TO: T10 Membership
FROM: Paul A. Suhler, Quantum Corporation
DATE: 3 November 2008
SUBJECT: T10/08-409r1, ADT-2: Internet ADT (iADT)

Changes to ADT-2 rev. 5

Figure 5 – ADT communication model

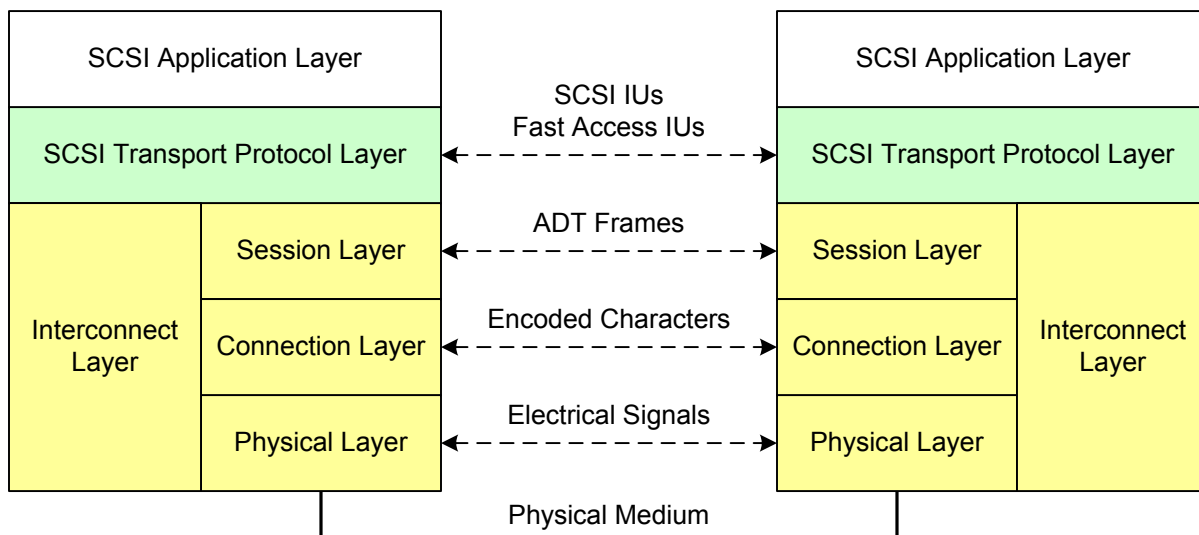
Figure 5 shows the communication between ADT ports at the different layers of the protocol, from the physical layer to the SCSI transport protocol layer.

Figure k – Connection State Diagram

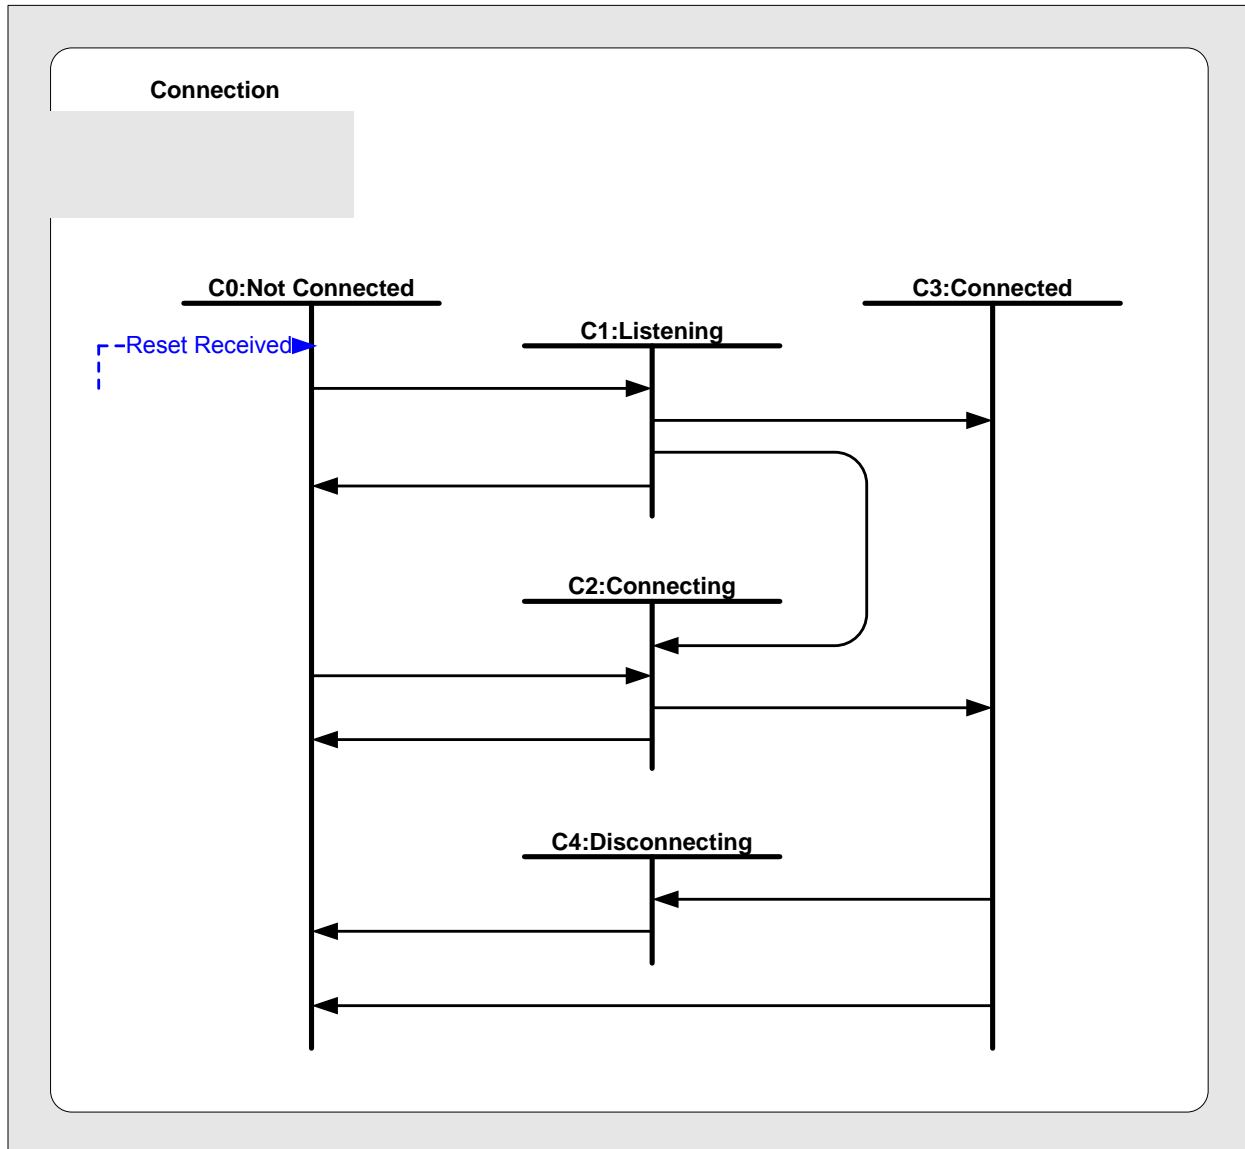
Figure k shows the connection state machine. The following subclauses describe the transitions and the actions taken in each state.

Note: We may want to add service requests as inputs, service indications as outputs, and other inputs to this figure.

Figure 18a – Connection services for establishing a connection between iADT ports

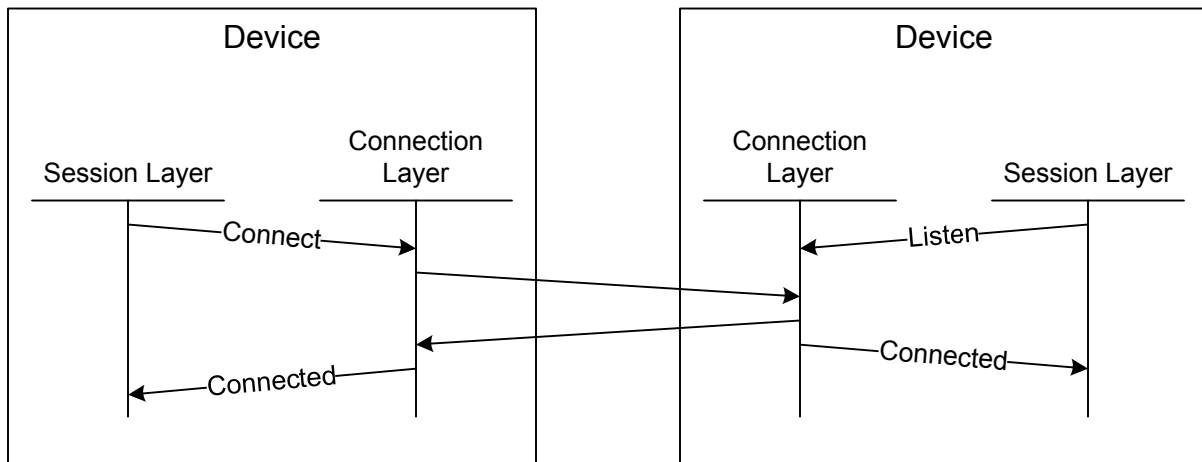
Figure 18a shows an example of the relationships among the connection services used to establish a connection between two iADT ports. The communication between the two devices is defined in RFC 793 and may constitute more than the two communications shown.

Figure 20a – Connection services for closing a connection between iADT ports

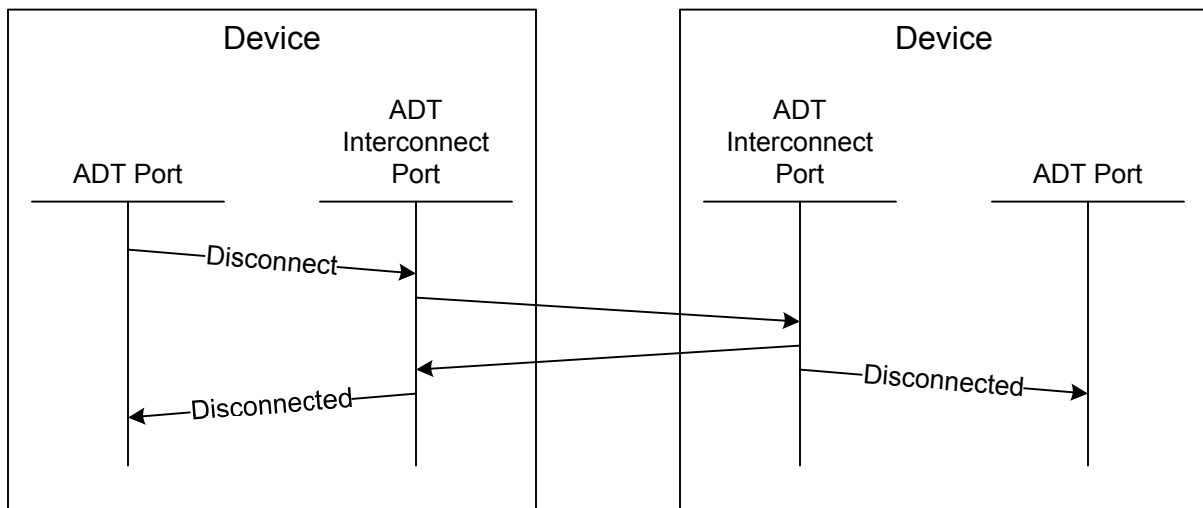
Figure 20a shows the relationships among the connection services used to close a connection between two iADT ports. The communication between the two devices is defined in RFC 793 and may constitute more than the two communications shown.
